TECHNICAL INFORMATION COMMUNICATION

Number: TIC2014-0013 Date: 12/1/2014

Title: Incorrect Indoor Coil Charge Addition

Product Category: Air Conditioners/Heat Pumps

Example wall control screen:

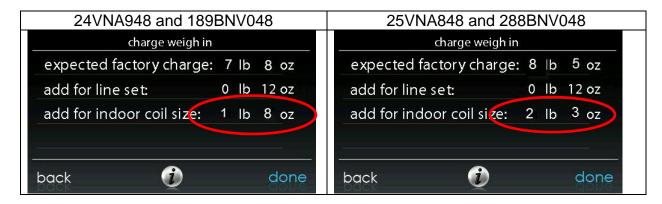
For air conditioner models 24VNA948 and 189BNV048, the wall control will display the value of 1 lb. 8 oz. additional refrigerant charge when the system is properly charged (rather than 0 lb. 0 oz.). For heat pump models 25VNA848 and 288BNV048, the wall control will display the value of 2 lbs. 3 oz. additional refrigerant charge when the system is properly charged (rather than 0 lb. 0 oz.).

A system that is overcharged may result in a fault code 71. The charge addition value is written into the circuit board (AOC) software and *will be corrected in version 3*.
